***Environmental
Planning
Commission***

***Agenda Number: 2
Project #: PR-2022-007141
Case #: SI-2022-01298
Hearing Date: August 18, 2022***

Staff Report

<i>Agent</i>	Consensus Planning Inc.
<i>Applicant</i>	Keystone Homes
<i>Request</i>	Major Amendment – EPC
<i>Legal Description</i>	Tracts A-1, A-2, A-3 and Tracts C-1, C-2, C-3 plat of tracts A-1 thru A-3 and C-1 thru C-3; and Tract B-1 (being a re-plat of Tract B), Heritage Marketplace
<i>Location</i>	1700 Unser Blvd. NW, between Hanover Rd. NW and Ladera Dr. NW
<i>Size</i>	Approximately 20 acres
<i>Existing Zoning</i>	MX-L

SITE PLAN

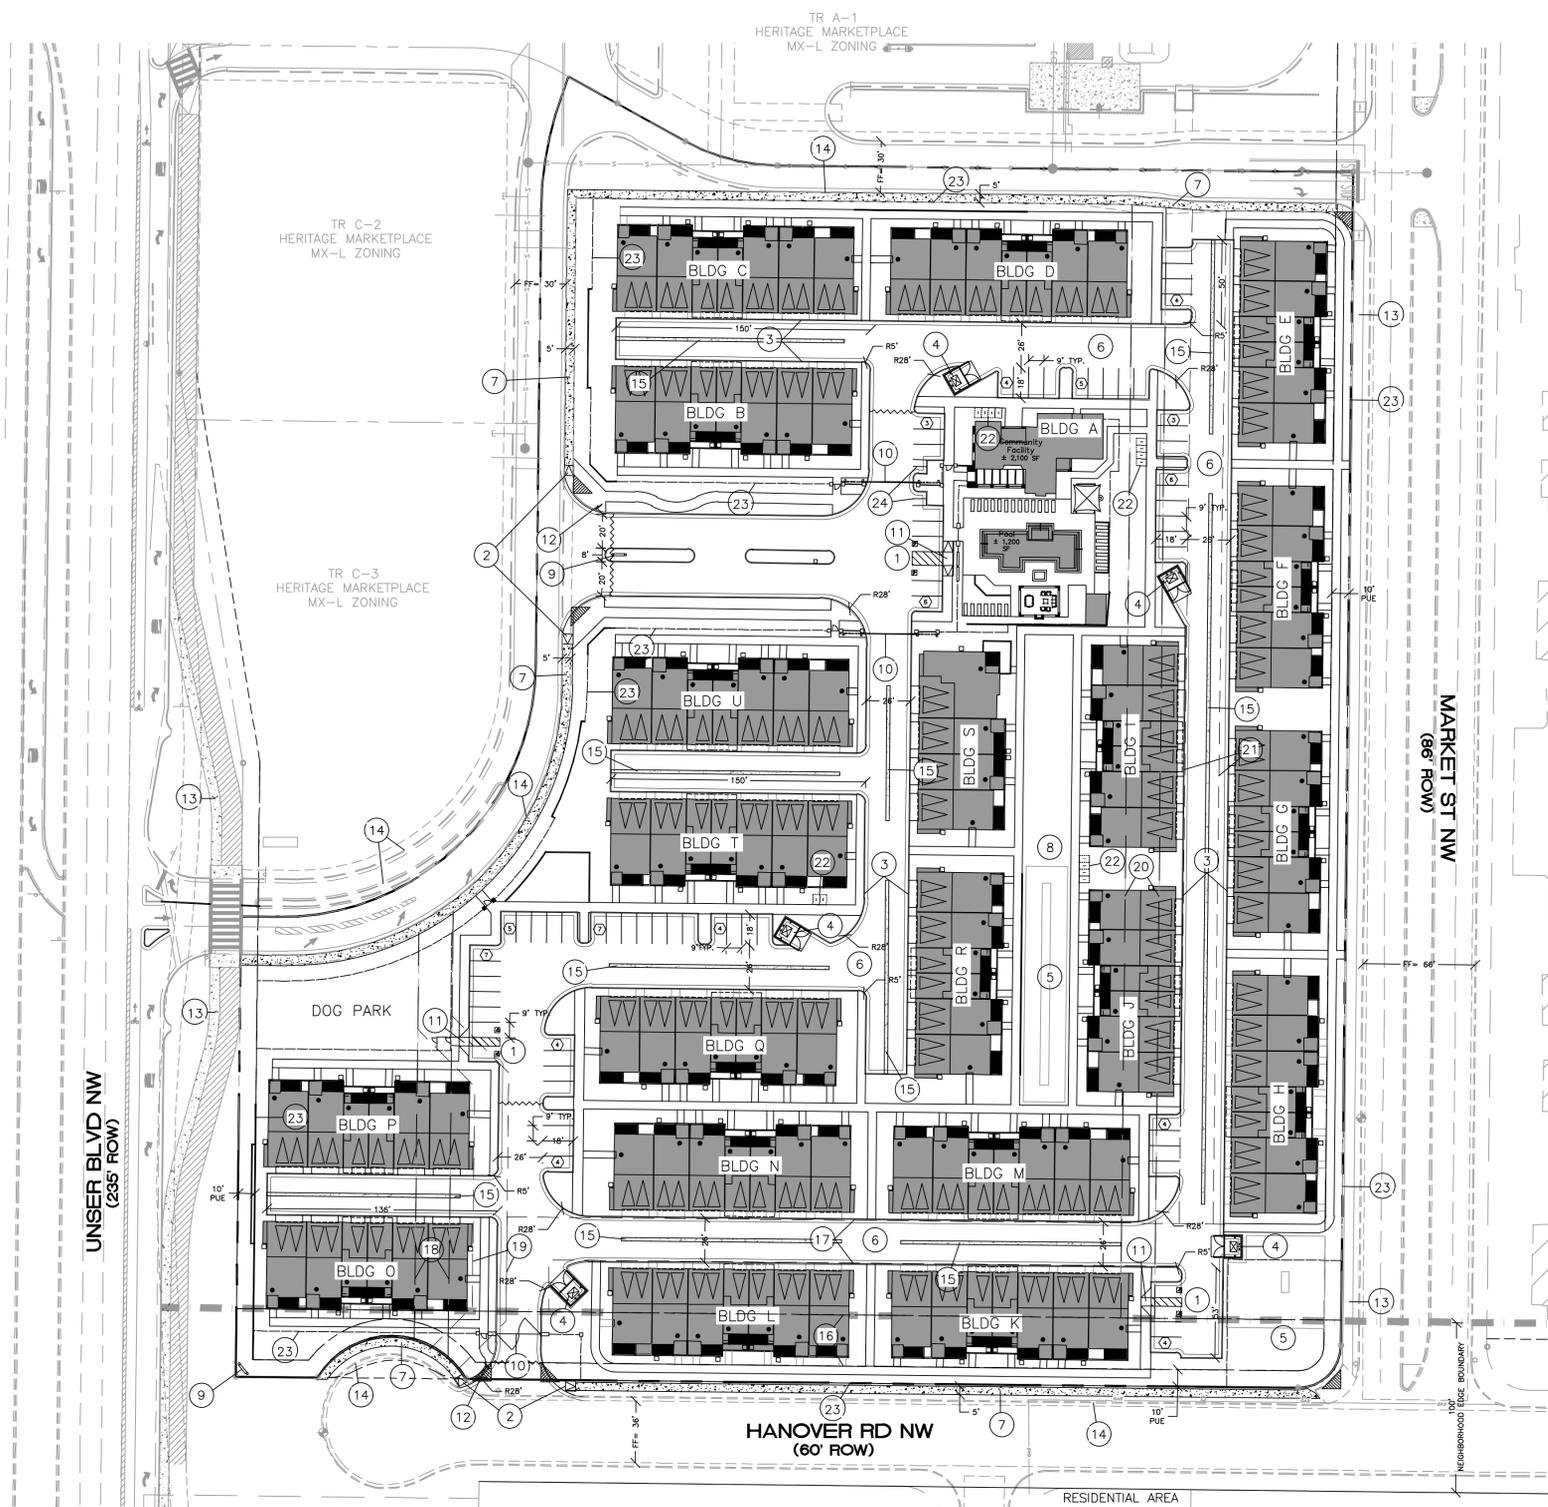
The request includes five proposed dumpster enclosures.
Provide dumpster enclosure details.

Monument signage must comply with the Heritage Marketplace design standards and will use IDO section 14-16-5-12 when standards are silent. Provide details.
